LONG ISLAND LIGHTING COMPANY

SNRC-577

Shoreham Nuclear Power Station - Unit 1 Docket No. 50-322

Forwarded herewith are sixty (60) copies of LILCO's responses to the Safety Evaluation Report (SER) Outstanding Issues listed in Attachment 1.

MAXIMUM DRYWELL PRESSURE
AT 1800 SEC VS. BREAK SIZE
A/VK= 0.16 ft 2-NO WETWELL THIN
STEEL OR DOWNCOMER HEAT TRANSFER

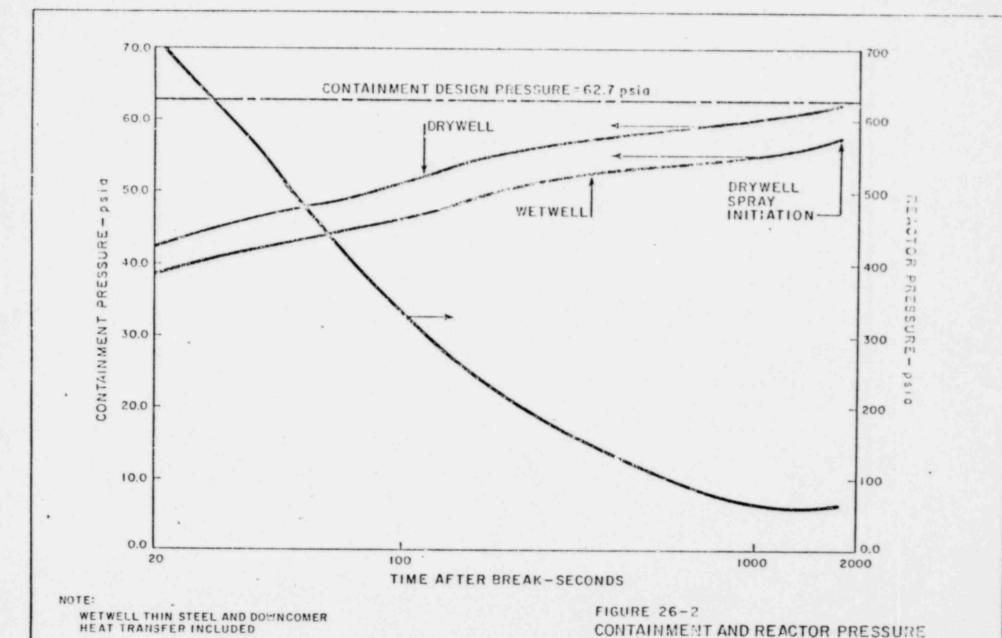
Figure 26-1 provides the results of the break size study. Note that there is very little variation in drywell pressure at 1,800 seconds with break size for a wide range of breaks. This is primarily a consequence of hot feedwater addition which tends to limit depressurization of the reactor at the end of the transient. (For example, for the 1.0 ft² break, the feedwater temperature at the end of the run is approximately 317°F corresponding to a saturation pressure of approximately 86 psia). The 1.0 ft² break is considered the limiting case.

FIGURE 28-2
PSD COMPARISON-7 KEY CHUGS
VS. 7 CHUGS USED FOR AVERAGING

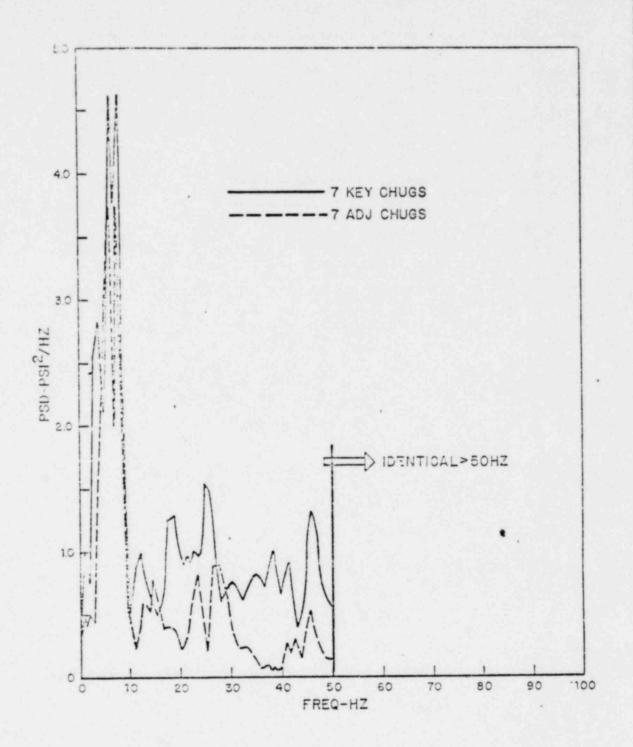
Because of the somewhat inconclusive nature of the limited ARS comparisons, Shoreham is submitting the following additional information. Pigure 28-1 shows a comparison of the PSD of the Shoreham confirmatory load definition in the JAERI-CRT facility with that of the accepted interim load. Two elevations are presented for the Shoreham confirmatory load: 3600 mm (vent exit plane) and 1800 mm. The Shoreham confirmatory PSD was generated with the same dephasing window as that used for plant application (50 msec), but instead of choosing the worst variance in 1,000 trials for individual chug start times, an "averaging" procedure was used (described in detail in Section 6.2 of the generic load definition report (NEDE-24302-P) to deliberately decrease the predicted wall pressures. The effect of this deliberate decrease in the predicted wall pressure loads is most pronounced at high frequencies.

Because of the decreased degree of conservatism in the method of application of the Shoreham confirmatory chugging load to the JAERI-CRT facility as compared to that used in the Shoreham evaluation. Shoreham considers the PSD comparison of JAERI-CRT shown in Figure 28-1 to be more than adequate for assessing the interim load effect on the Shoreham plant. An inspection of Figure 28-1 shows an exceedence of the Shoreham confirmatory by the interim only at approximately 2 hz. The reason for this exceedence is that the condensation event at t = 25.3 sec in Run 26 was considered in the interim load definition to be a chug
